Subject Re: Response to Comments on Background Sampling

RE: Proposed Scope of Work – Background Sampling Investigation
RI/FS Activities - Gibbsboro, New Jersey

The attached Figure 1 entitled Proposed Background Locations provides the proposed locations, by media, for the background sampling investigation.

Soil Sampling Profiles ⁽¹⁾ Based on Depth

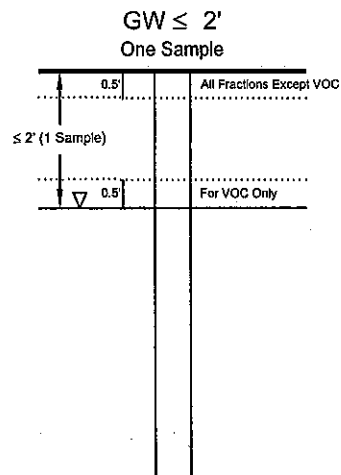
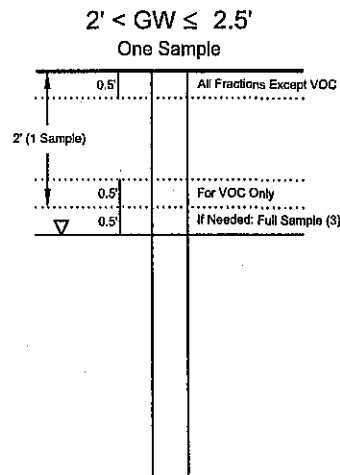
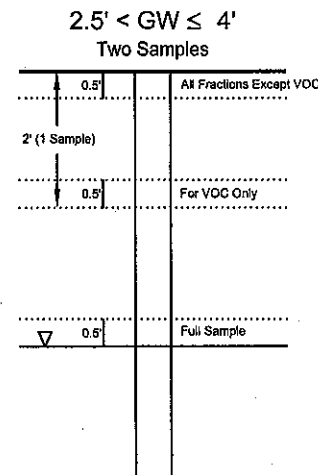
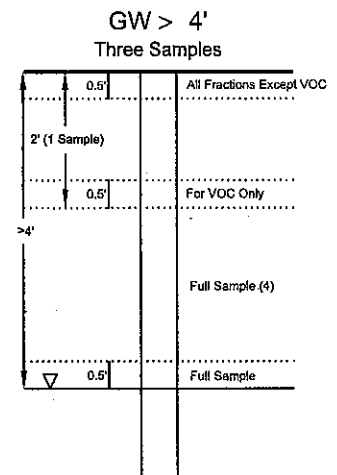
Although we will have specific geological information, in the form of soil logs generated from the monitoring well installation procedures, the sampling program is not set up in this fashion. Rather I would suggest that the existing protocols, which are provided in Addendum #1 be utilized. Specifically, I would recommend that the sampling procedures for within the ?fenced-in areas? (i.e., U.S. Ave. Burn and Rt. 561 Dump Site) be utilized, and that an equal number samples be located upland and near creeks be selected.

c. Background soil samples are proposed from two distinct depths (i.e., 0-24" and 0-6" above water table); however, the sampling scheme should follow the sampling depth intervals as defined by SWC in their June 9, 2004 Addendum #1 (to the 2003 Work Plan). This would require that if the groundwater is greater than 4", then samples are collected from 3 distinct intervals.

c. Background soil samples are proposed from two distinct depths (i.e., 0-24" and 0-6" above water table); however, the sampling scheme should follow the sampling depth intervals as defined by SWC in their June 9, 2004 Addendum #1 (to the 2003 Work Plan). This would require that if the groundwater is greater than 4", then samples are collected from 3 distinct intervals.

Our current strategy of collecting a sample from 0-6" bgs and 6 inches above the water table satisfies this requirement. These two samples should provide sufficient information for background comparison.
